PLANNING TECHNICAL REVIEW COMMITTEE –AGENDA

TECHNICAL REVIEW COMMITTEE MINUTES – WAIV-2023-0004

Application Type: Site Review
Applicant(s): Kniphfer LLC
Owner(s): Kniphfer LLC
Location: 43 Back River Road (Tax Map I, Lot 55-A)
Date: June 22, 2023

A&M Project #: 3188-01
Re: TRC Response
Tax Map I, Lot 55-A
43 Back River Road

DRAWING TITLE:	SHEET No.
SIGHT DISTANCE FIGURE	C-4

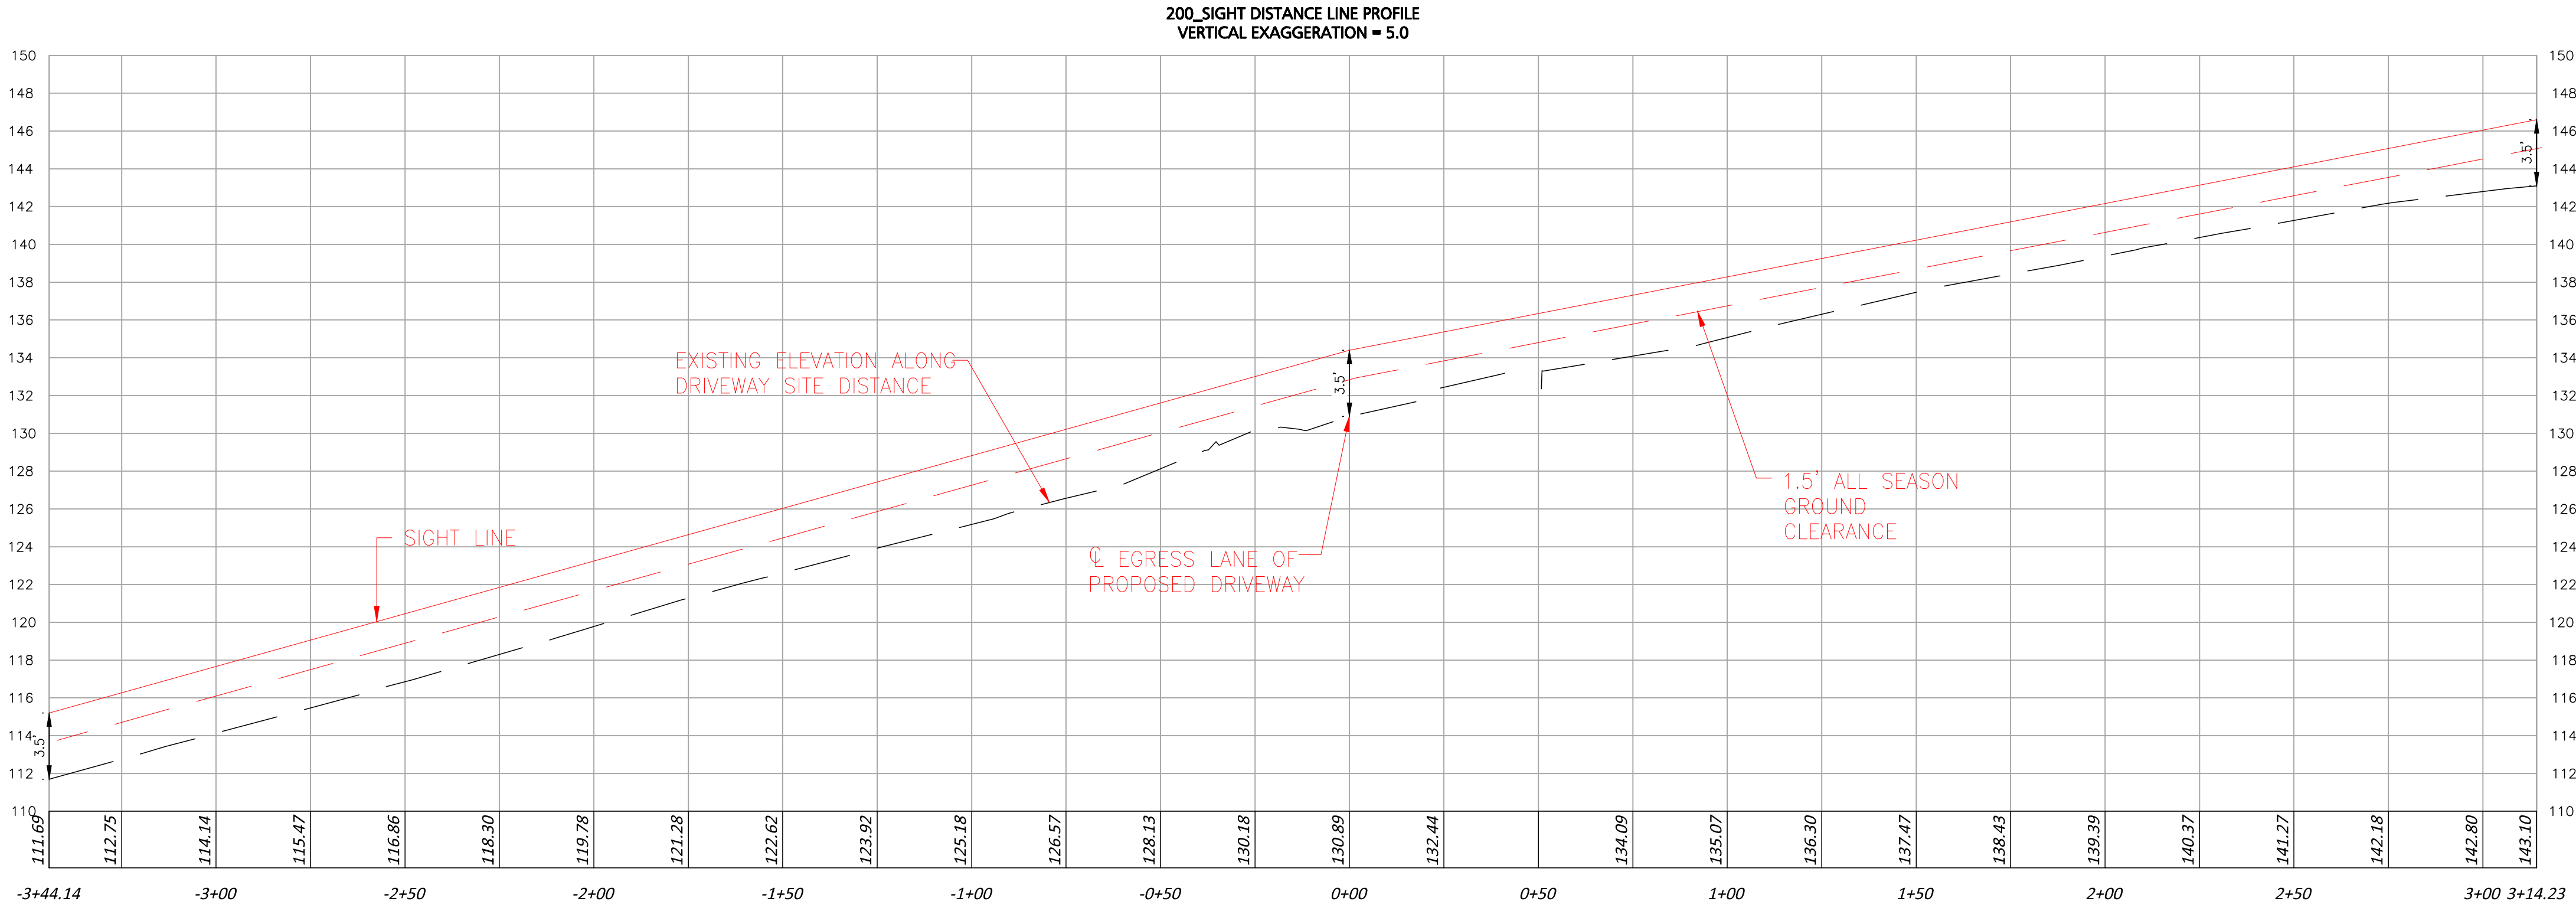
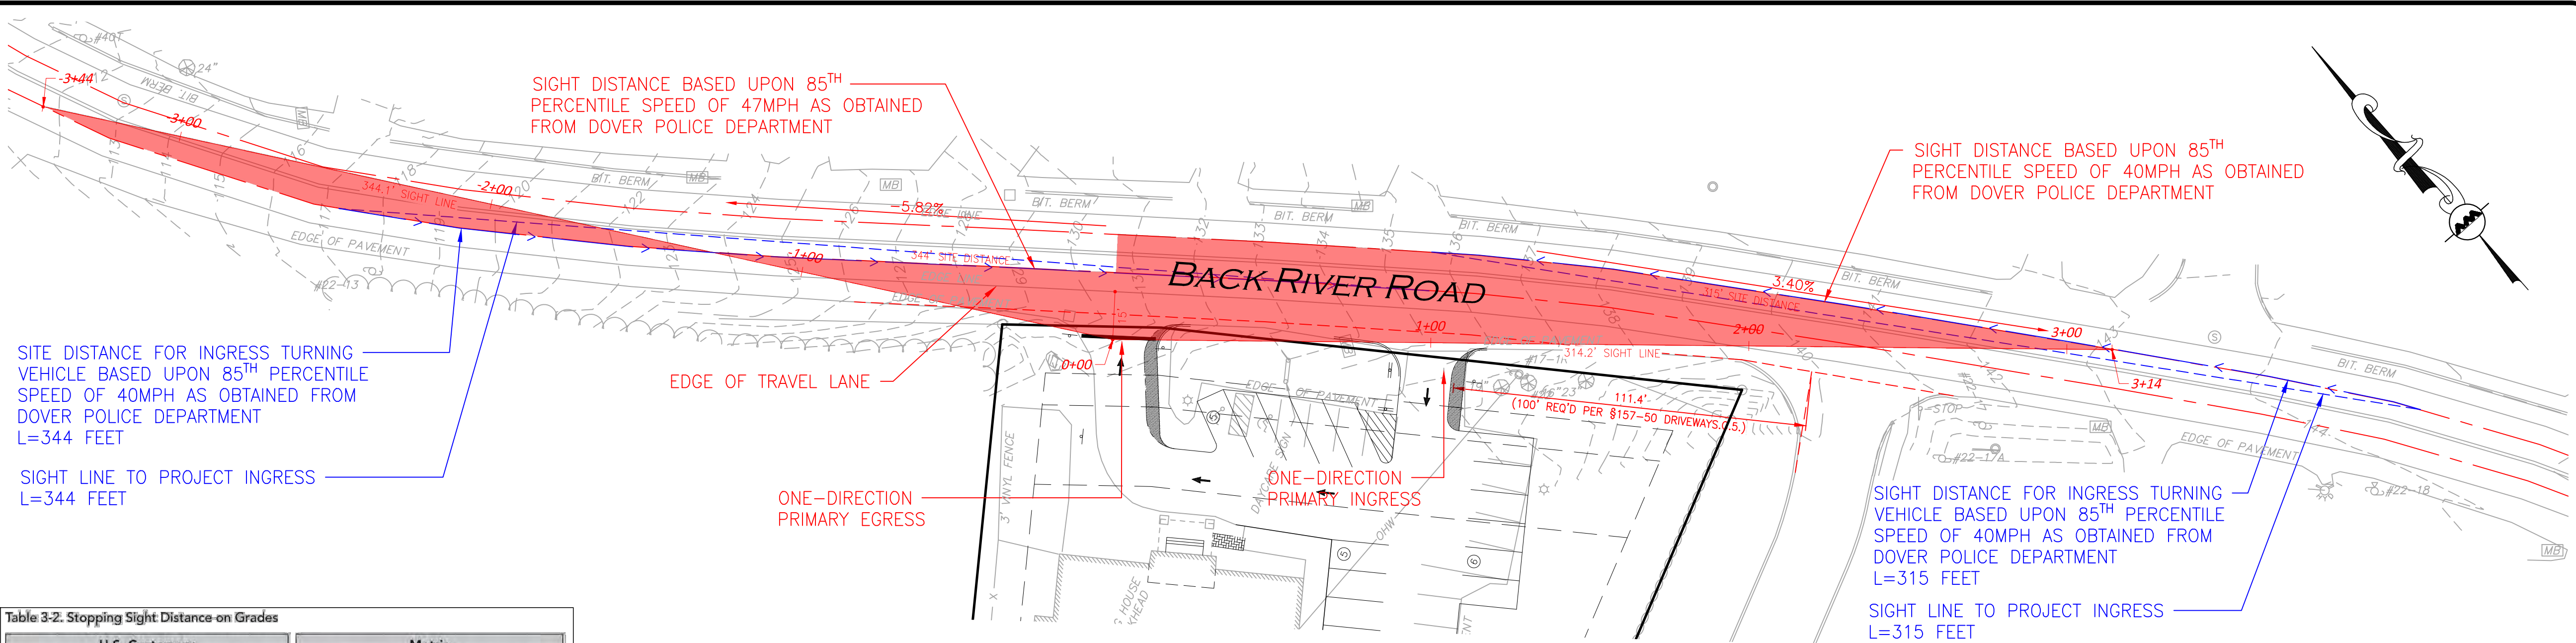
- *Sight distance plan-what if driver SB is closer to edge of pavement than center line? Harder for a car to see exiting?*

A&M Response: The sight distance in both NB and SB has been calculated from a vehicle within the appropriate path of travel along Back River Road. Based on the demarcated travel lanes along the road, vehicles should not legally be closer to the pavement than is shown on the plans.
